GLOBAL SAFETY FIELD INVESTIGATIONS
DCS5827
URGENT - DISTRIBUTE IMMEDIATELY

Subject: N212336951 - Emission Recall
Incorrect OBD System on VECI Label

Models: 2021 Chevrolet Express
2021 GMC Savana

N212336951 Incorrect OBD System on VECI Label

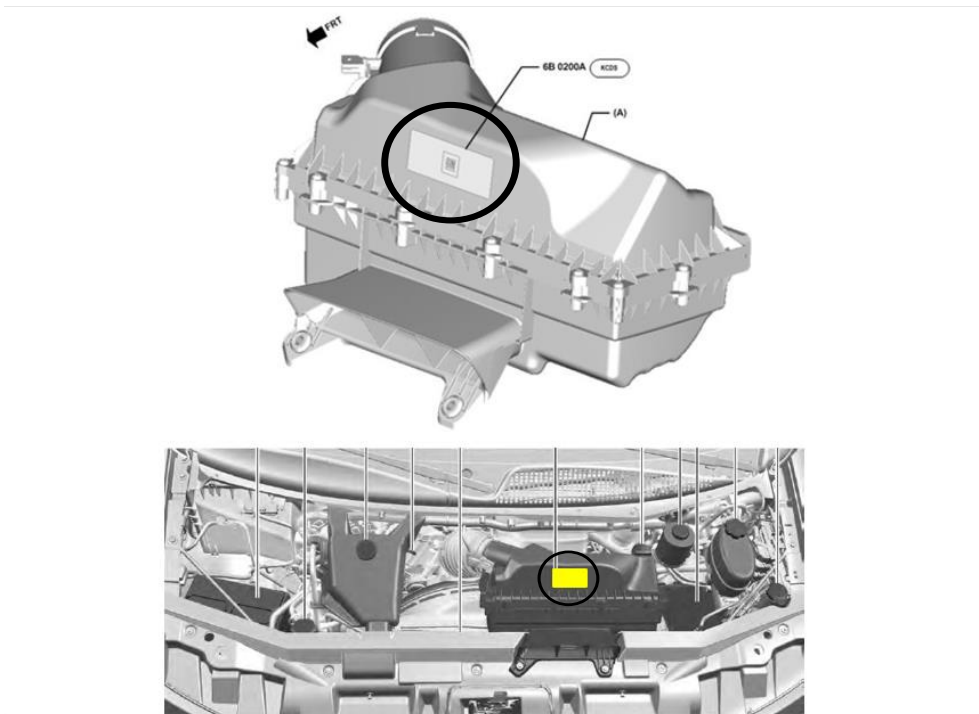
2. Locate the Vehicle Emission Control Information (VECI) Label on the airbox, in the location circled.
